Millstone Nuclear Power Station, Unit No. 2
Resolution of Open Items
Amendment 89 to DPR-65

Millstone Nuclear Power Station, Unit No. 2

Resolution of Open Items

Confirmation of Sleeve Plugging Limit

Figure
4.3-2

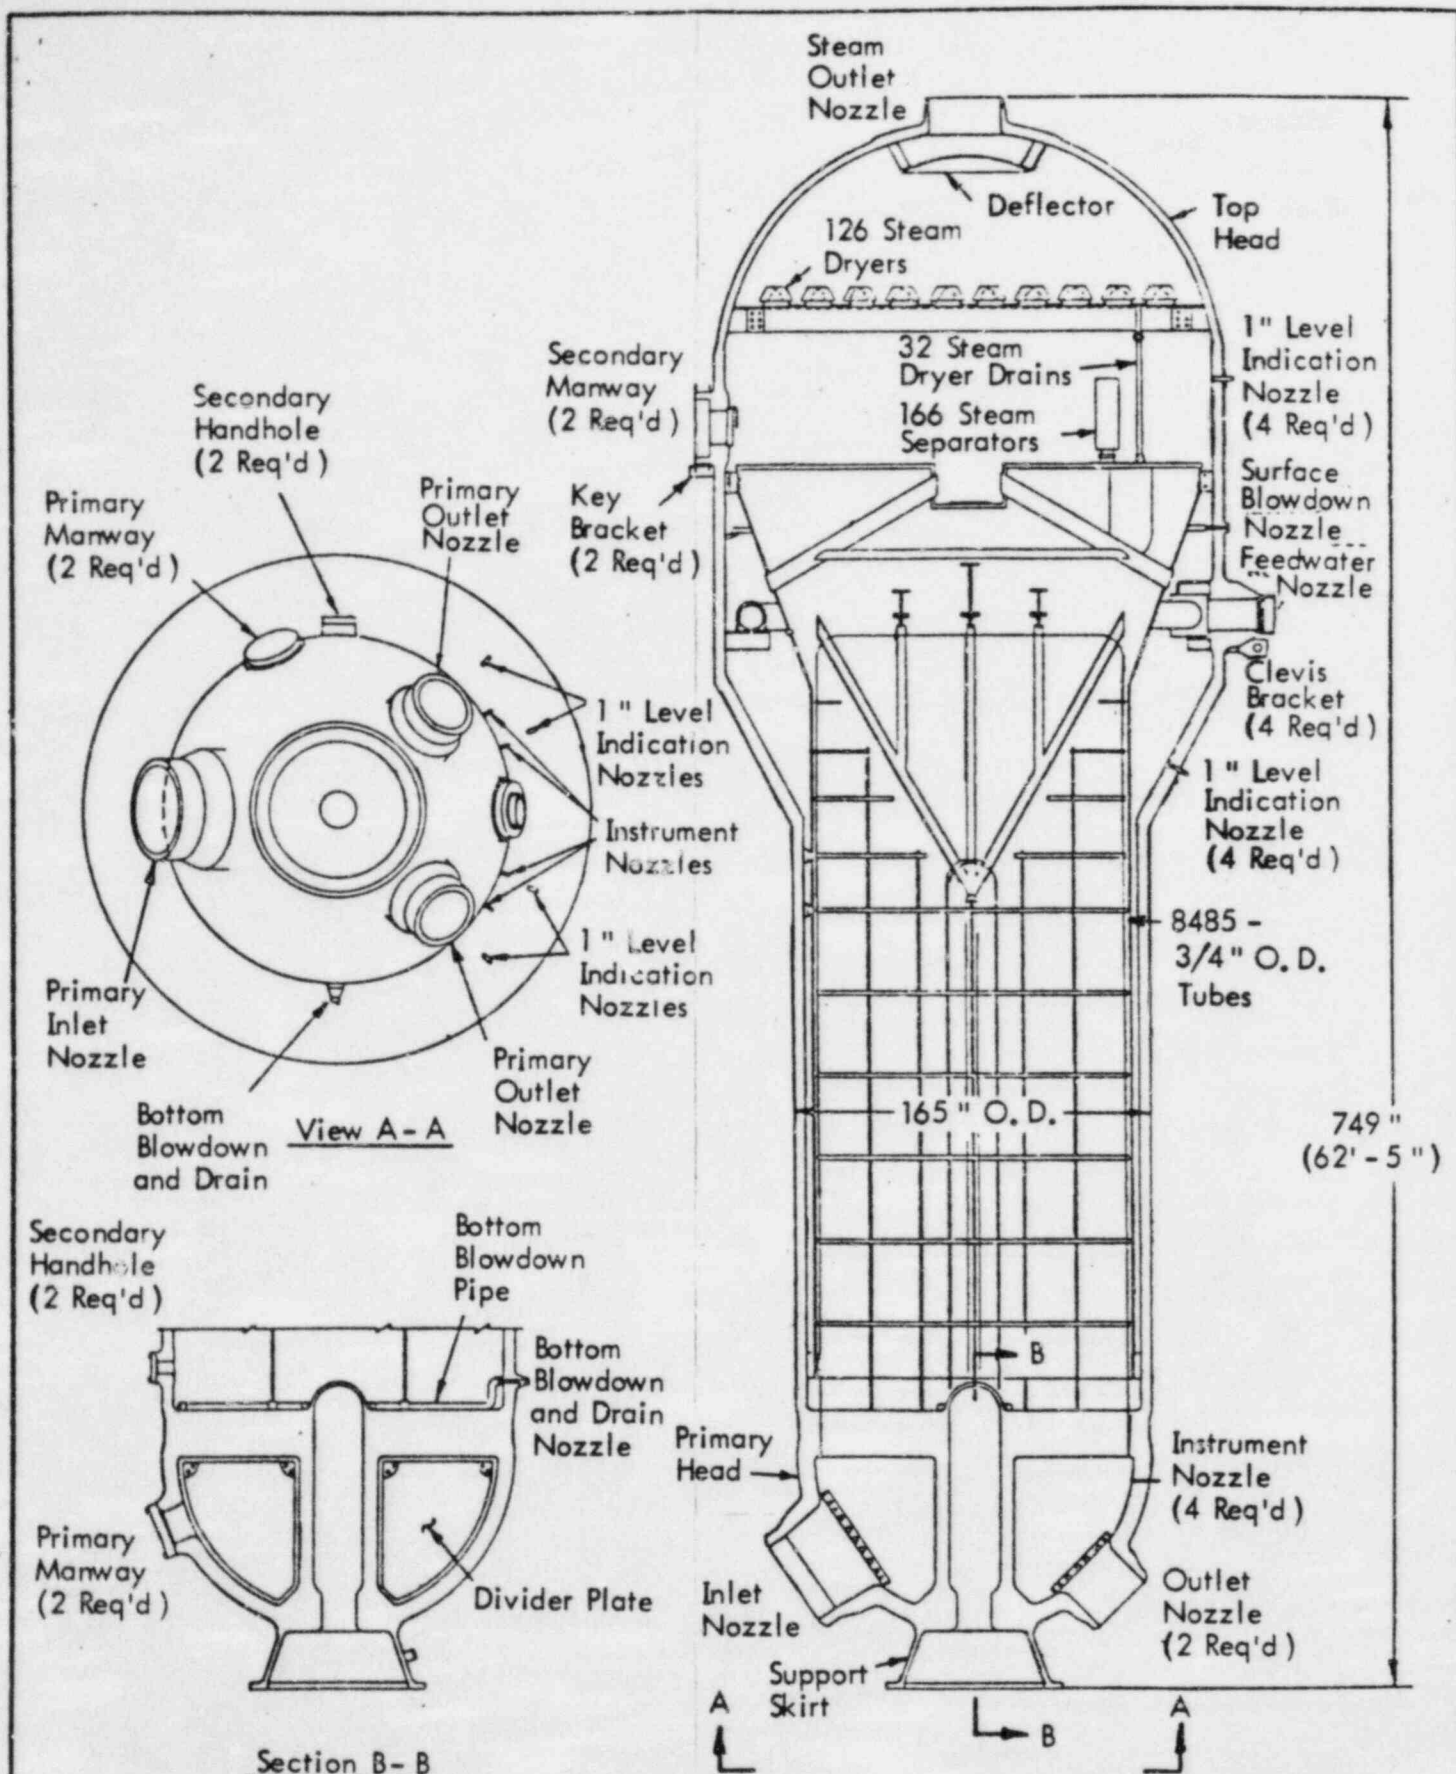
Millstone Unit No. 2 employs a Combustion Engineering design nuclear steam supply system. Each of the two steam generators contain 8519 tubes in a U-bend configuration. The tubes are arranged in a triangular pitch. The tube sheet is 21.5 inches thick and 14 feet in diameter. Since the pressure is normally higher on the primary side of the tube sheet than on the secondary side, the tube sheet becomes concave upward. The tube sheet flexes further during a main steamline break due to the larger pressure differential between the primary and secondary sides of the steam generator. Design features have been incorporated into the steam generator to limit the tube sheet deflection. The most notable feature of the Millstone Unit No. 2 steam generator design is the stay cylinder depicted in Figure 4.3-2 of the FSAR included herein.
